NO.	DATE:	DESCRIPTION:
1	06/10/19	FOR APPROVAL

8TH FLOOR
SHEET METAL PLAN

136 MADISON AVENUE
8TH FLOOR
NEW YORK, NY 10016

8TH FLOOR - SHEET METAL PLAN

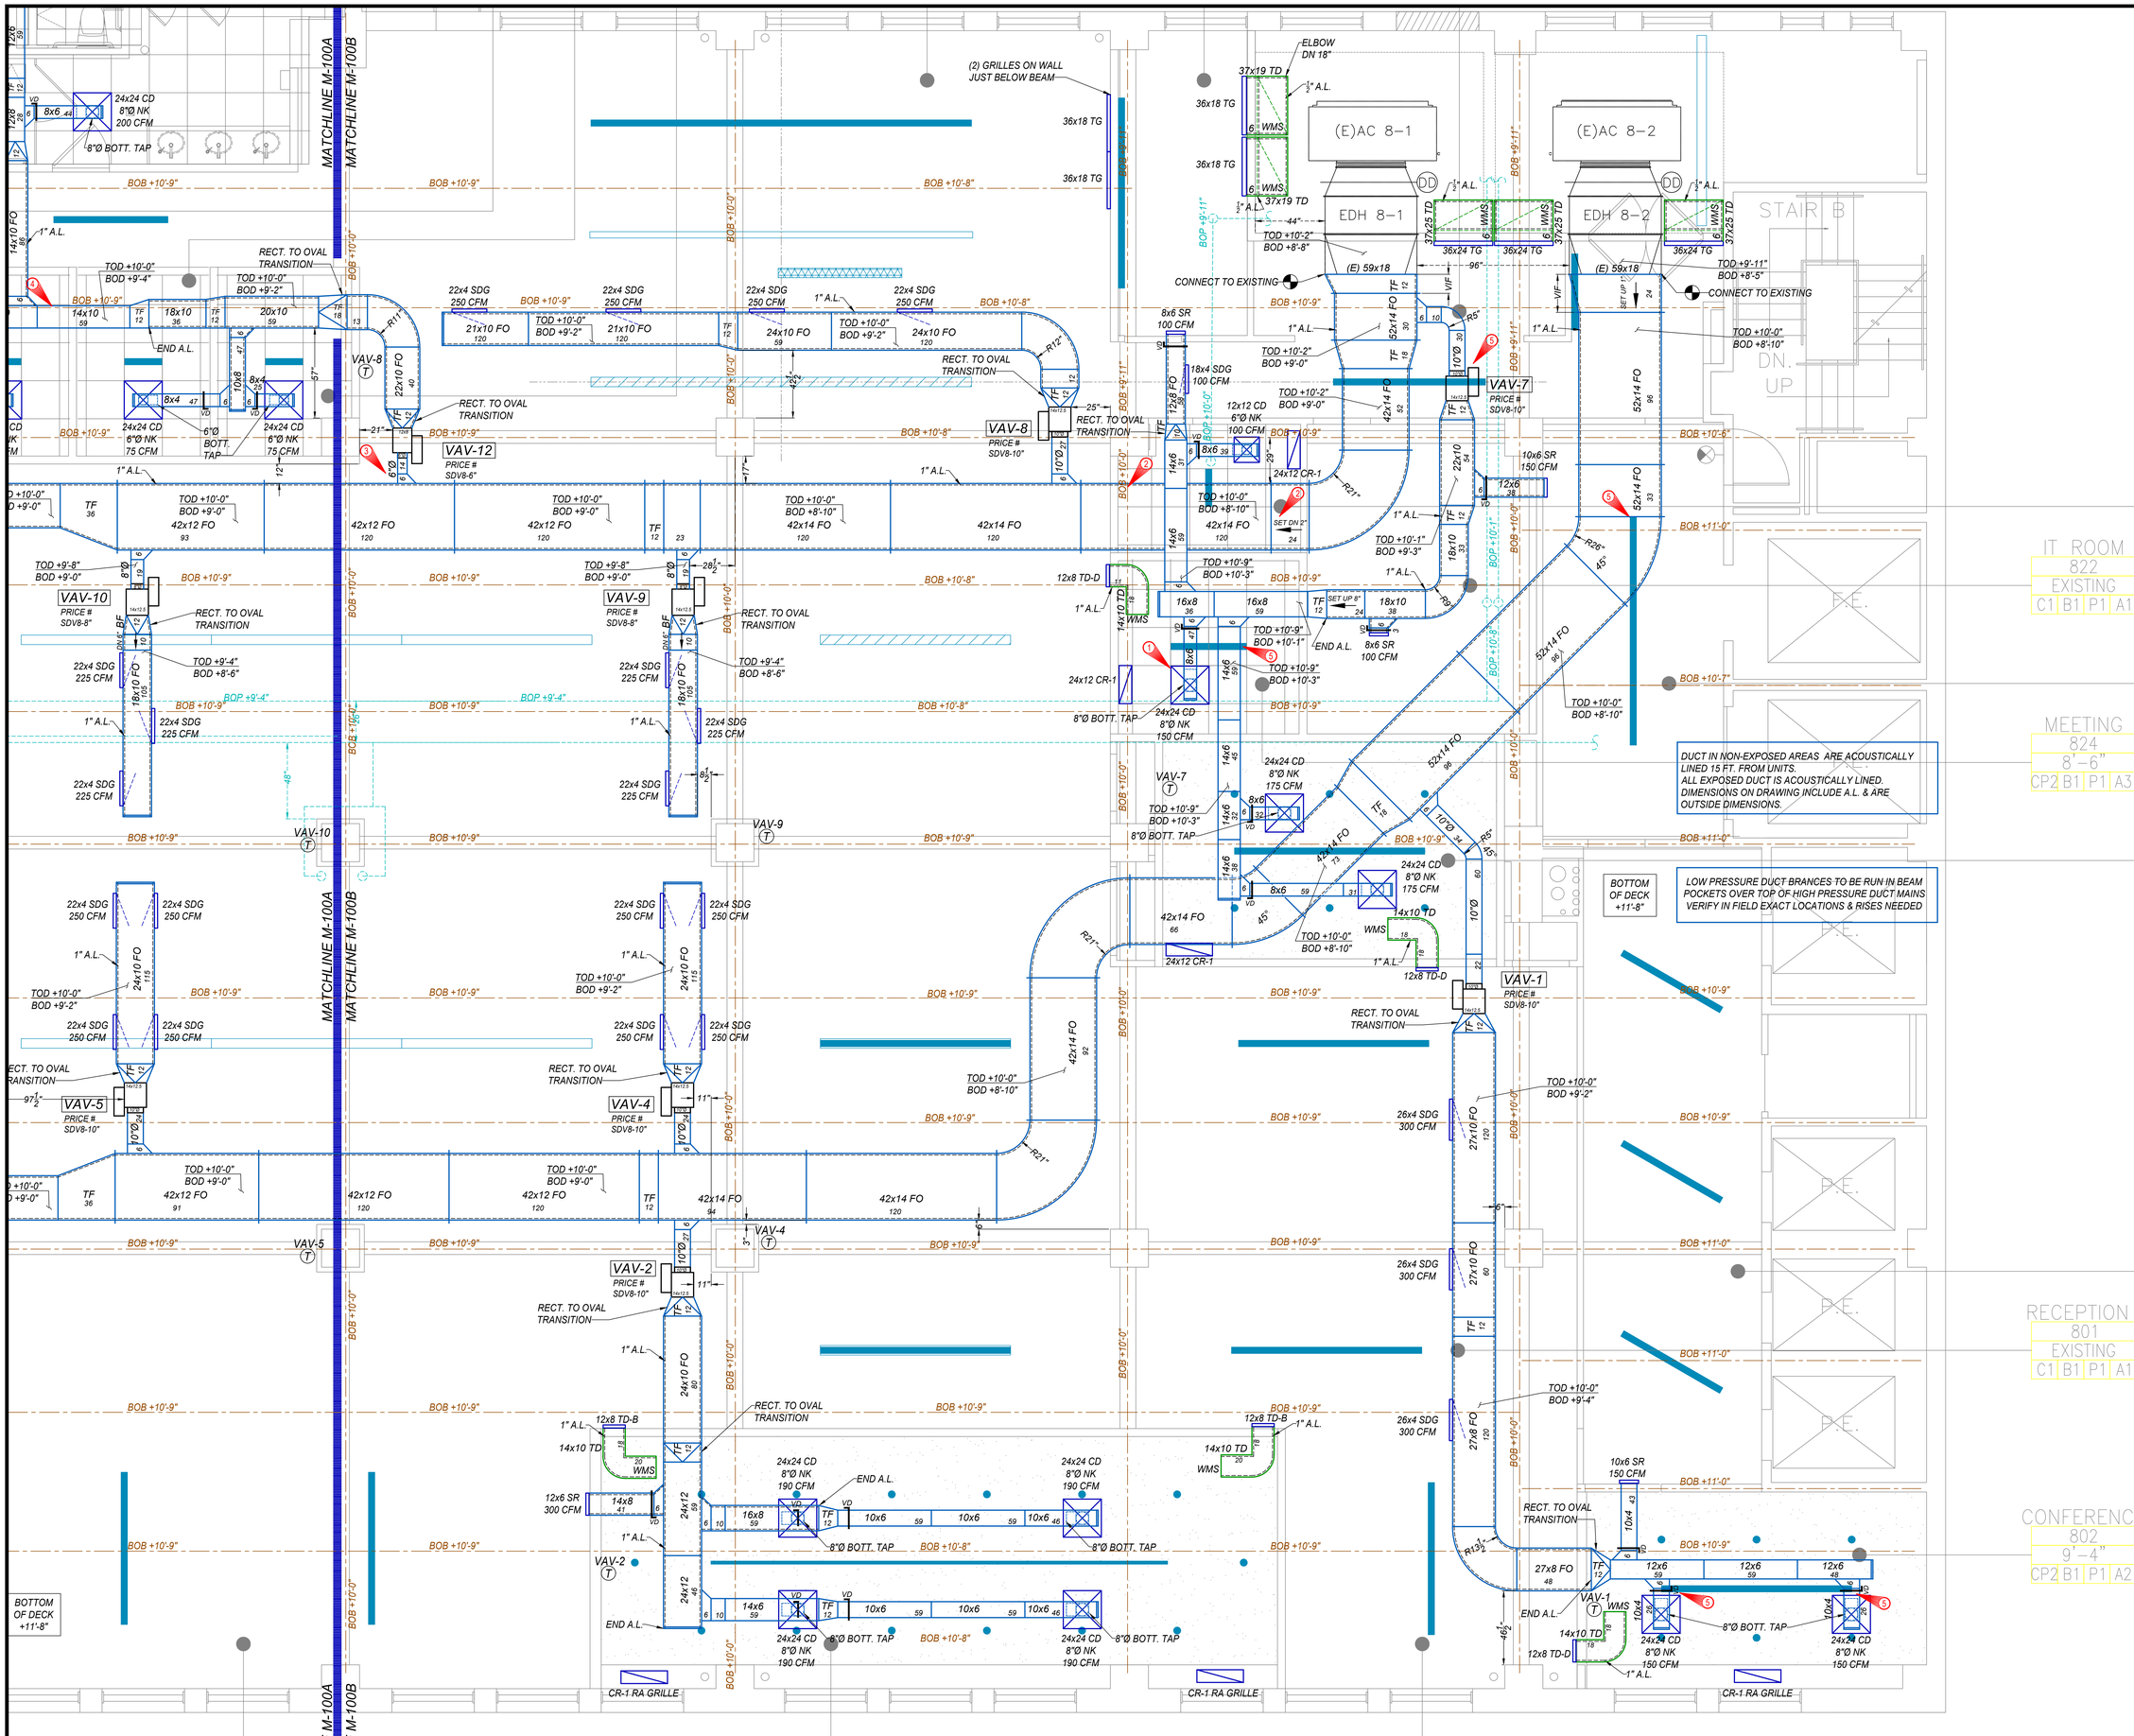
1. GRILLE MOVED OFF OF LIGHTING, ENGINEER TO ADVISE IF NEW LOCATION IS OK
2. PLEASE ADVISE IF SET IS NECESSARY AND CAN DUCT BE RUN AT 10'-2" BY NOTCHING 2" OFF OF BEAM.
3. DRAWING CALL FOR A DIFFERENT INTAKE DIAMETER THAN THE EQUIPMENT SUBMITTAL. DRAFTER FOLLOWED THE SUBMITTAL FOR INLET SIZE. PLEASE ADVISE.
4. NOT ON THIS SHEET
5. POSSIBLE CONFLICT W/ LIGHTING
